Access Compliance Report

Public Rights-of-Way

Intersection ID: N/A	Main Street: LABEAU_AV	Cross Street: MORABLIN_DR	Location: W
ADA ID: 4AD8BE857445	Ramp Type: PerpDiag	Initial Pass/Fail: Fail	Overall Compliance: No
			Severity Score: 33.75

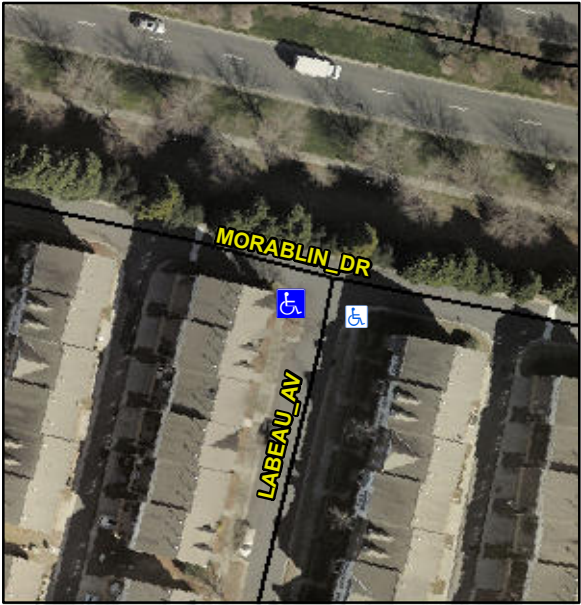
Codes/Mitigation Info/Possible Solution			Field Measurements/Component Compliance			
	Possible Solutions:		Compliance	Description	Data	Compliance
	Remove & Replace Curb Ramp With Two New Directional Ramps or Equivalent.		No	Ramp Length (in)	123.0	No
			No	Ramp Width (in)	44.0	No
			N/A	Flare Type LT	N/A	N/A
			N/A	Flare Slope LT (%)	N/A	N/A
			N/A	Flare Traversable LT?	N/A	N/A
			N/A	Landing Length (in)	N/A	N/A
			N/A	Landing Width (in)	N/A	N/A
			N/A	Landing Slope (%)	N/A	N/A
			N/A	Landing X Slope (%)	N/A	N/A
Surveyor Notes: N/A PROW/ADA: Not Found, R304.5.1, R304.2.2, R304.5.3			N/A	Flare Type RT	N/A	N/A
			N/A	Flare Slope RT (%)	N/A	N/A
			N/A	Flare Traversable RT?	N/A	N/A
			N/A	DWS Provided?	N/A	N/A
			N/A	DWS Contrast?	N/A	N/A
			N/A	DWS Length (in)	N/A	N/A
			N/A	DWS Full Width?	N/A	N/A
			N/A	DWS Offset (in)	N/A	N/A
			N/A	Gutter Ponding?	N/A	N/A
			N/A	Gutter Lip Ht (in)	N/A	N/A
Total Cost: \$ 3200.00			No	Painted X Walk1?	No	N/A
